# HISTORIC AND DESIGN REVIEW COMMISSION

**HDRC CASE NO:** 2022-283  
**ADDRESS:** 119 E MAGNOLIA AVE  
**LEGAL DESCRIPTION:** NCB 1703 BLK 8 LOT 18 AND 19  
**ZONING:** R-4, H  
**CITY COUNCIL DIST.:** 1  
**DISTRICT:** Monte Vista Historic District  
**APPLICANT:** Dustin O'Connor/Guido  
**OWNER:** Charles Ramon/RAMON CHARLES  
**TYPE OF WORK:** Window replacement  
**APPLICATION RECEIVED:** May 10, 2022  
**60-DAY REVIEW:** Not applicable due to City Council Emergency Orders  
**CASE MANAGER:** Rachel Rettaliata

## REQUEST:

The applicant is requesting a Certificate of Appropriateness for approval to replace all existing wood windows and empty openings with aluminum-clad wood windows.

# Site Visit Notes

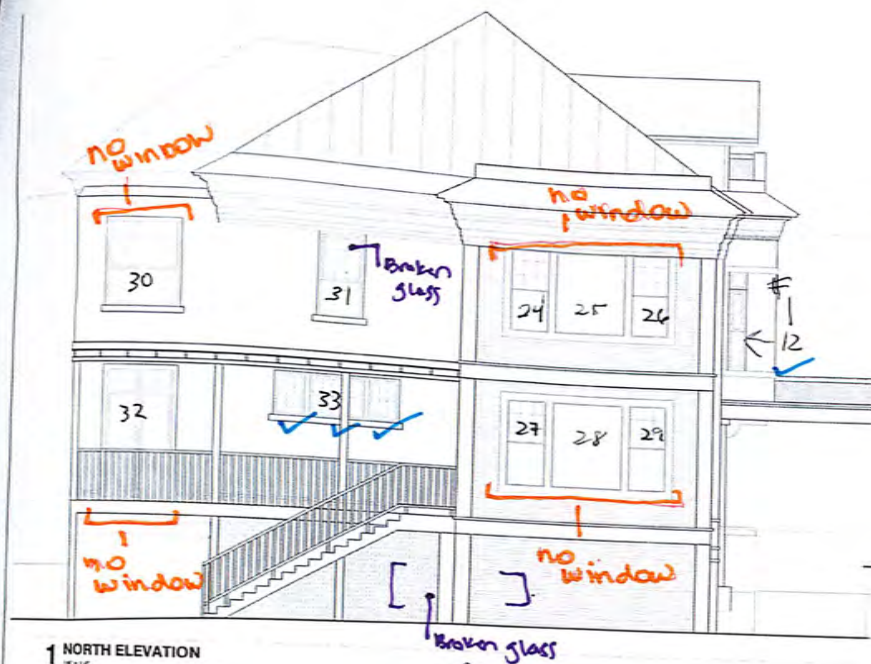
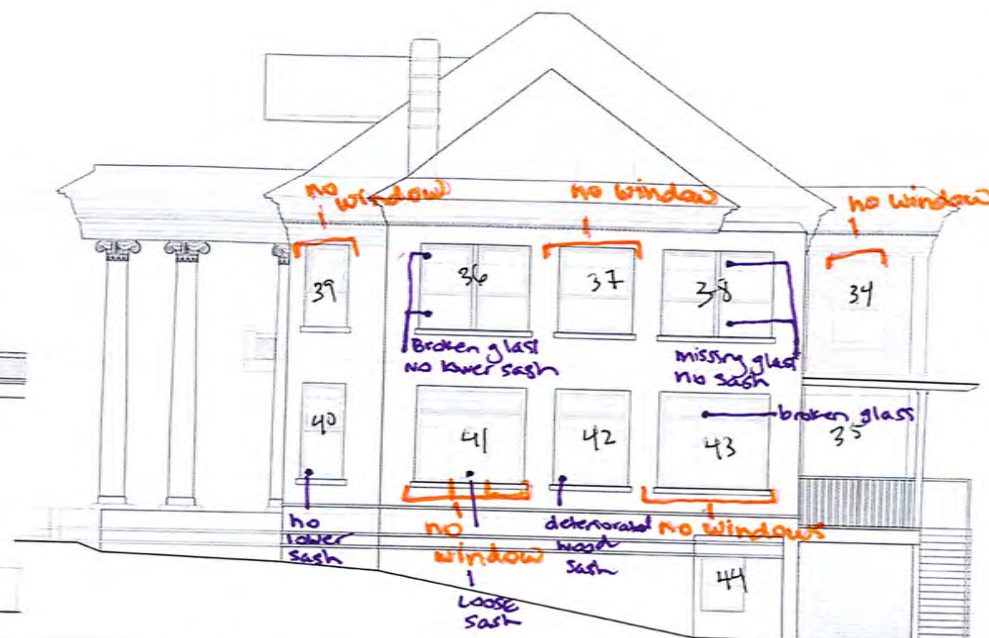
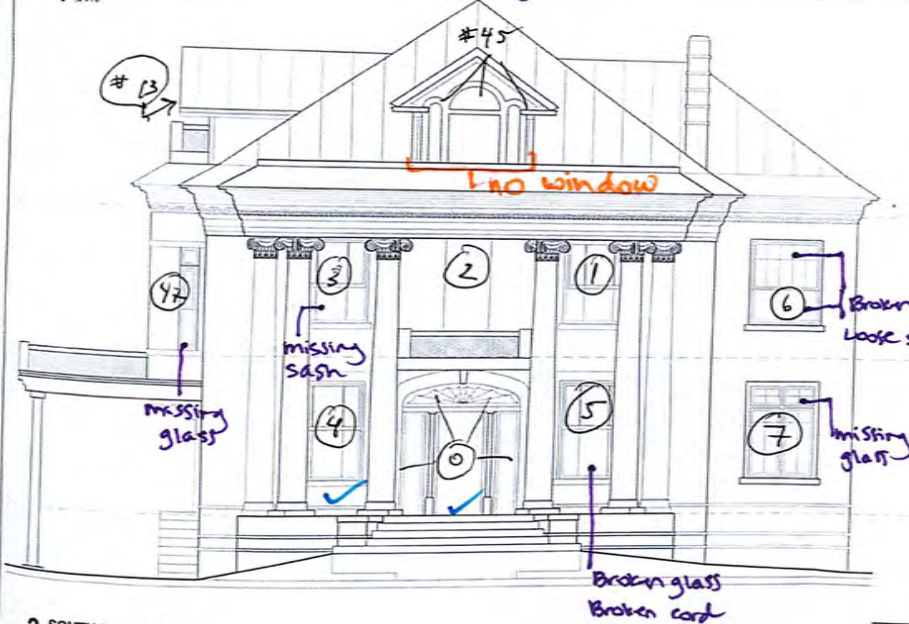
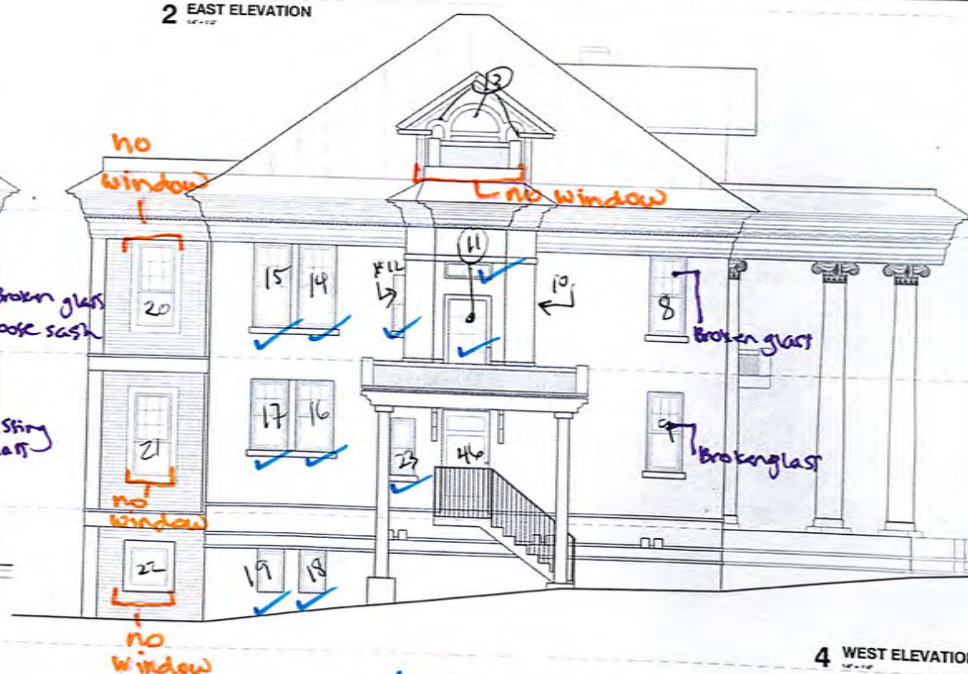
- c. **WINDOW REPLACEMENT: EXISTING CONDITION** – Staff conducted a site visit on May 23, 2022, and

observed the following conditions on the existing original wood windows: damaged and peeling or chipping paint, broken or missing cords, and loose or broken glass. Some of the existing windows may require reglazing or the reworking of the sashes. Window #42 exhibits signs of deterioration in the sash. Overall, the windows do not show signs of significant wood rot, wood damage, or severe deterioration. In the April 2018 application for window restoration, a representative for the property owner provided a window schedule indicating that the majority of the windows were able to be restored based on their condition. Staff finds that all remaining wood windows are in repairable condition, with most requiring minimal repair and intervention like re-glazing and painting, along with refitting into the trim and frames. Several window openings are missing windows completely or are missing an entire sash or most of the sash elements. These windows are identified as windows #13, 20, 21, 22, 24, 25, 26, 27, 28, 29, 30, 31, 34, 37, 39, 41, 43, and 45. These 18 windows are eligible for the installation of fully wood windows to match existing in size, type, configuration, material, form, appearance, and detail.

Staff does not recommend approval of the window replacement based on findings a through f. Staff recommends that the original request, to restore existing wood windows and replace in-kind, approved by the HDRC on April 4, 2018, be upheld. The empty openings are eligible for the installation of fully wood windows that meet staff's standard window stipulations.
